The following policies and rules, which require modifications of aircraft for the purpose of remedying defects affecting airworthiness, are hereby adopted. They shall become effective upon publication in the **FEDERAL REGISTER** unless otherwise indicated, in order to promote safety of the flying public. Compliance with the notice, procedures, and effective date provisions of section 4 of the Administrative Procedure Act would be impracticable and contrary to the public interest and, therefore is not required.

Sulphur Dusters.	48-34-2	<p>3. Airworthiness directives which remain in effect (CAA rules). Modifications and inspections of civil aircraft, as described below, are mandatory. Aircraft which are not modified and inspected as required herein are considered unairworthy, and continued flight of such aircraft will be regarded as violations of the Civil Air Regulations.</p> <p>AIRWORTHINESS DIRECTIVE ISSUED IN 1939. WHICH REMAINS IN EFFECT</p> <p>29-24-1. DOUGLAS (Was Service Note 1 of AD-618-3 and Service Note 1 of AD-693-3)</p> <p>A. INSPECTION.—1. Attach angles. Inspect joint at the following intervals of wing</p> <p>602-20 and 21, for cracks between the attachment bolt holes.

FIGURE 1.

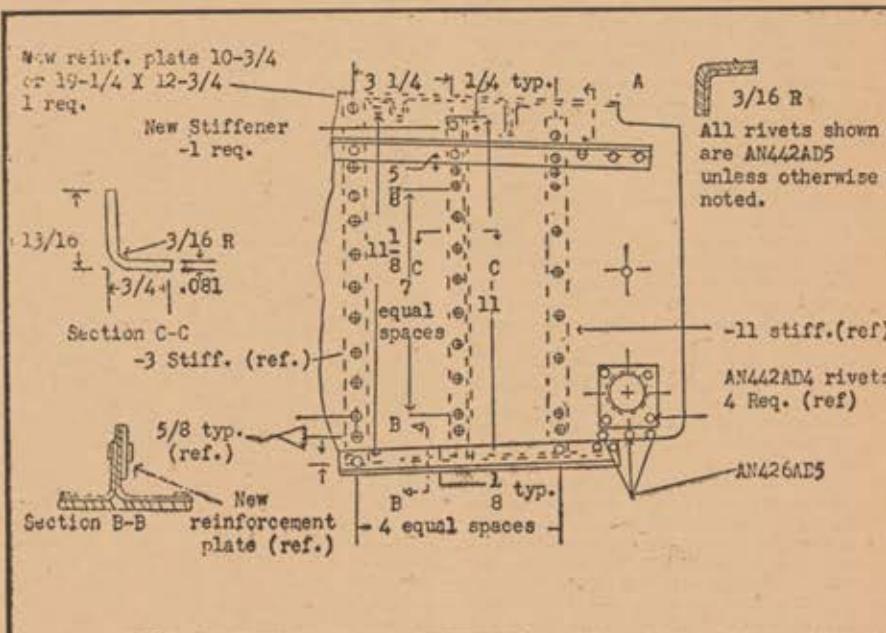
(1) Remove the first and second stiffeners forward of the rear spar, parts -3 and -11 in figure 1.

(2) Remove all rivets through the rib in the area from the rear spar to the forward of the two stiffeners removed, except the rivets through the bottom flange of the rib.

(3) Replace the original reinforcement plate with a new reinforcement plate made of 0.051-inch 24ST alclad. The new reinforcement plate should be 10 $\frac{1}{4}$ inches long and otherwise should be in accordance with figure 1.

(5) Install a new stiffener made of 0.081-inch 24ST alclad to the dimensions and at the location shown in figure 1.

FIGURE 2.

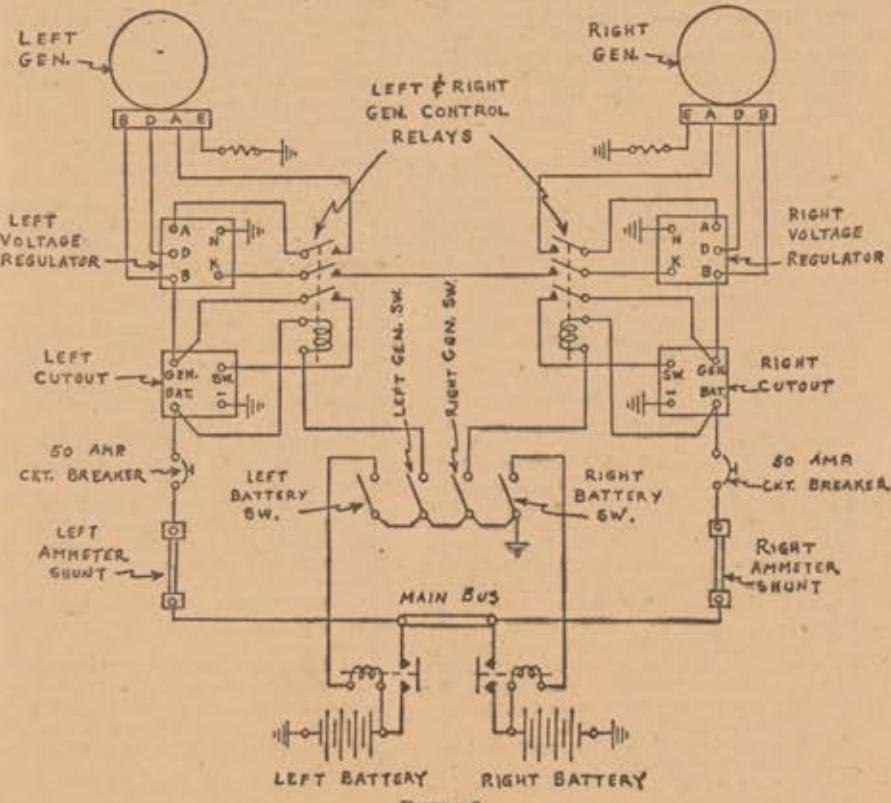
To be accomplished prior to certification or, if certificated, on next periodic inspection but not later than October 1, 1947. In accordance with Figure 2 (Page 30) install a three-pole-single-throw relay, General Electric No. CR2791-B100G3 or equivalent, for the control of each generator. The operating coil of the left generator relay should be controlled by a single-pole-single-throw "On-Off" switch mounted on the pilot's control panel adjacent to the left battery switch, and should be labeled "Left Gen. Sw.". The operating coil of the right generator relay should be controlled by a single-pole-single-throw "On-Off" switch mounted on the pilot's control panel adjacent to the right battery switch and should be labeled "Right Gen. Sw.". The battery and generator switches should be located adjacent to each other in the order shown on Figure 2, and should be provided with a suitable gang-bar such that pilot can throw the four switches to the "Off" position in a single operation.

To be accomplished prior to certification or, if certificated, on next periodic inspection but not later than October 1, 1947. In accordance with figure 2 install a 50-ampere trip-free circuit breaker, Spencer Thermostat Co. PLM-50 or equivalent, between the battery terminal of each generator cut-out and its respective ammeter shunt. The circuit breakers should be accessible in flight and labeled respectively: "LEFT GEN. CIRCUIT" and "RIGHT GEN. CIRCUIT."

FIGURE 3.

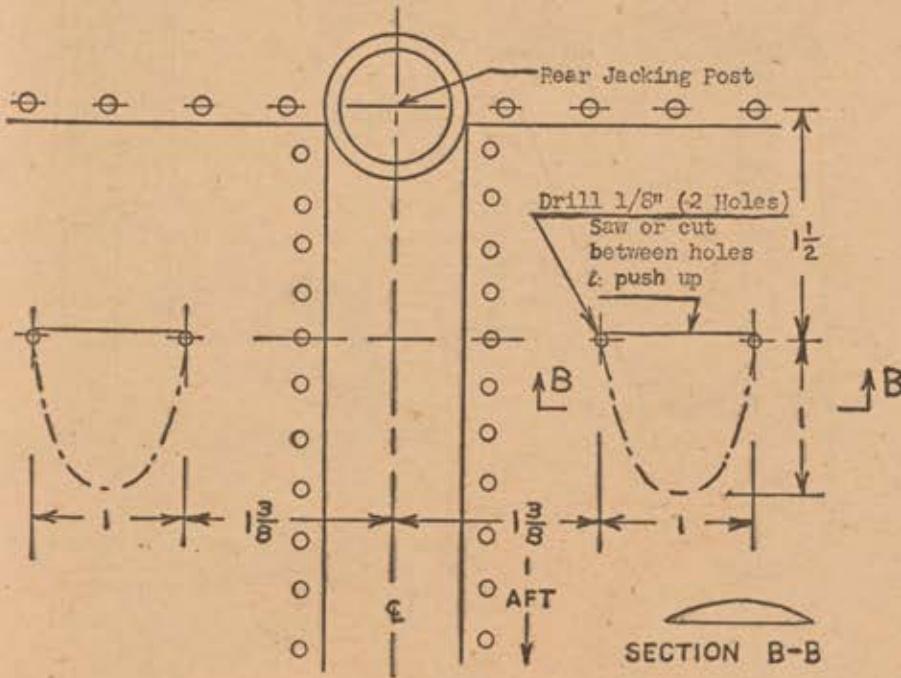
No. 15 as shown in figure 3. (Beech Service Bulletin No. C18-7 covers this same subject.)

FIGURE 5.

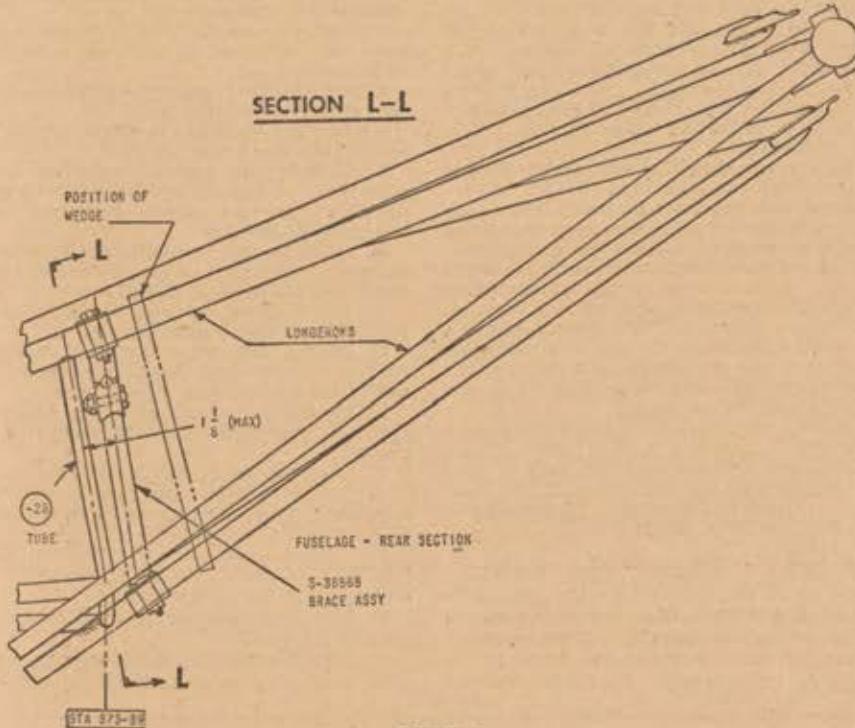
(4) Reinstall the stiffeners and other parts removed, using rivets in accordance with figure 5.

FIGURE 8.

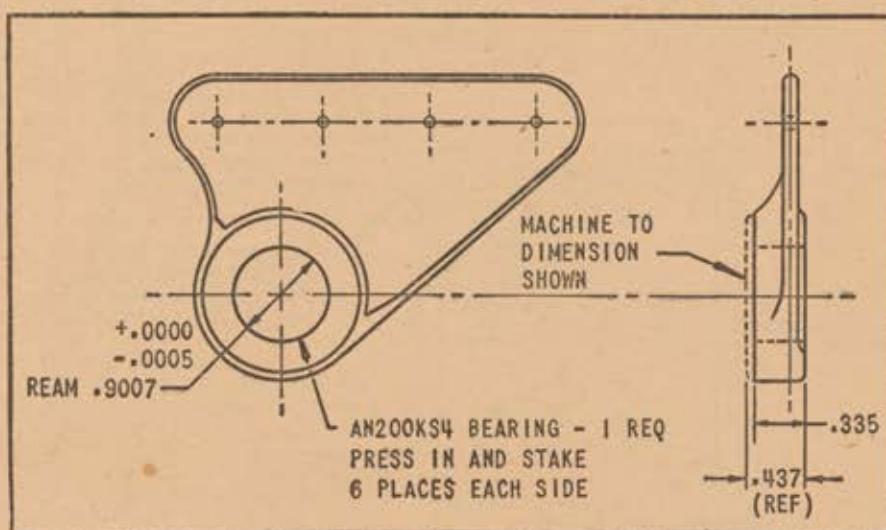
1. Machine face of boss on fitting assemblies part Nos. 4154028 and 4154028-1, to 0.335 inch, and ream bore to 0.0007 plus 0.0000, minus 0.0005 inch. (See fig. 8. Replace bearing AN209K4A with self-aligning bearing, part No. AN200KS4 and stake in six places each side. Install reworked fitting assemblies, part Nos. 4154028 and 4154028-1, on original bulkheads as follows:

FIG. 11

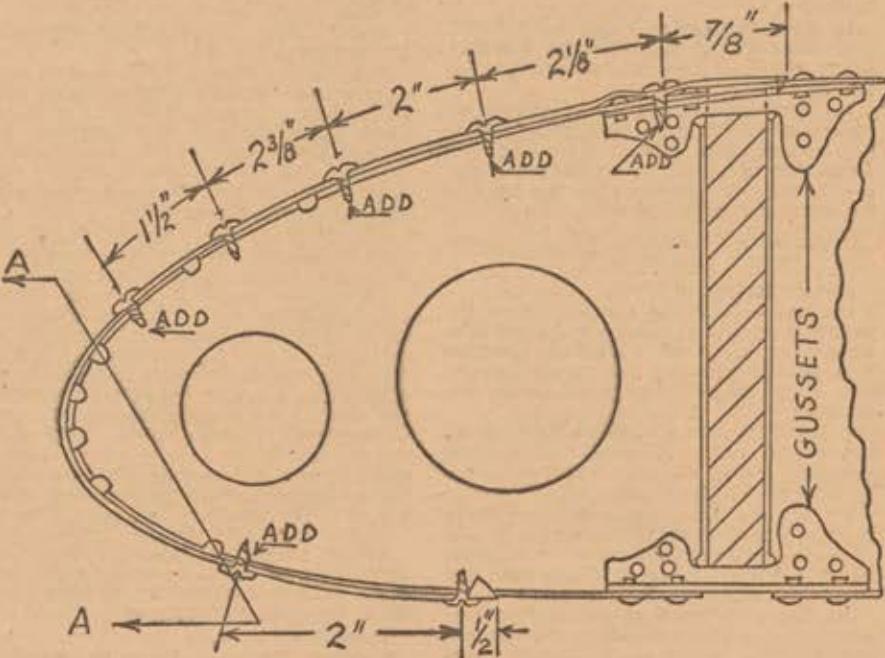
Compliance required by March 1, 1948. Inspect the wing leading edge for buckled nose ribs or loose PK screws by pressing leading edge skin with hand to nose ribs. If the skin can be depressed beyond the normal wing contour, other than the extreme nose radius, indicated by section A-A in figure 11, the fabric should be cut open on the bottom surface just forward of the front spar for thorough inspection. Item No. 1 below should be accomplished on all wings whether damage has occurred or not, whereas Item No. 2 pertains only to damaged ribs found in the above inspection. Repair need not be made if buckling is confined to area forward of section A-A of figure 11.

1. To help prevent further failures of the nose ribs five additional No. 4 x $\frac{1}{4}$ PK screws or, as an alternate, Cherry CR163-4-2 rivets or equivalent are to be installed in all nose ribs. Four PK screws or rivets are to be installed on the top surface and one PK screw or rivet is to be installed in the bottom as shown in figure 15. Apply dope liberally under the PK screw head before tightening. It is not necessary to remove the fabric to accomplish this modification.

2. Damaged ribs should be cut away at the top and bottom of spar. The new nose ribs are installed by means of two gussets on the side of the ribs as shown in Figure 11. Factory kits, Aeronca part Nos. 5-185-2 and 5-190-2, are to be used. (Aeronca Helps and Hints No. 17 with three supplements thereto covers this same subject.)

FIGURE 13.

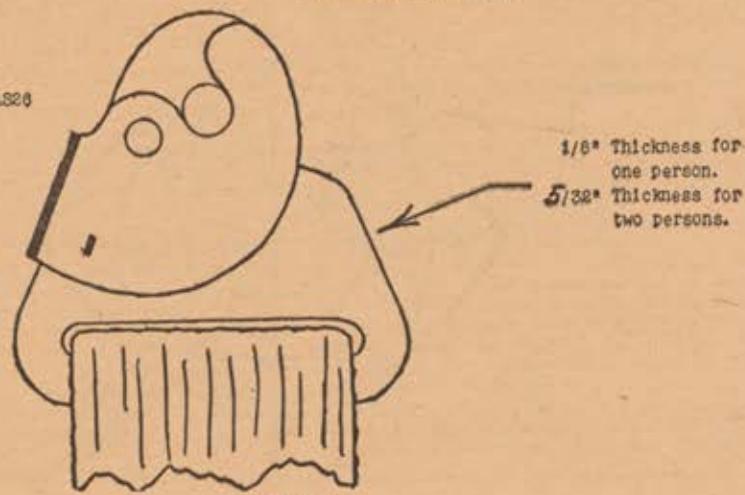
To be accomplished as soon as possible but not later than May 1, 1950. Warren McArthur end fittings, P/N 275-AS26, (Air Associates P/N M-1842) have been found to be of insufficient strength for use in two-person belts. These fittings are not marked, have a fitting plate thickness of $\frac{1}{8}$ inch, and may be identified by comparison with figure 13. Belts using these fittings must be modified so that the label will read "Approved for One Person." This may be done by blanking out the words "or Two" and the letter "s" in the word "Persons" on the label with India ink or an equally effective method. All such belts presently used in two-person applications shall be removed and replaced by other belts approved for two persons.

FIGURE 14.

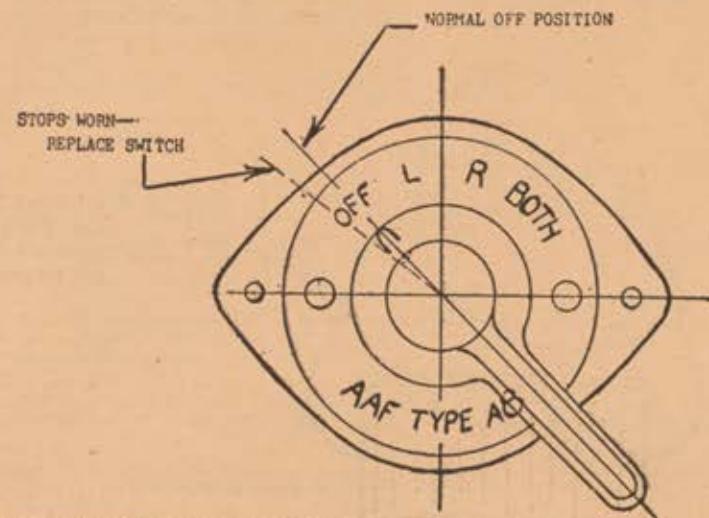
1. Inspection should consist of the following: Check switch lever for overtravel past the "off" position. Figure 14 shows the location of the switch lever in the "off" position. The pointer projecting from the lever points to the middle "f" in the word "Off." When the lever can be turned to a point beyond the centerline of the "O" in the word "Off," the rotation stops have become worn and the switch should be replaced.
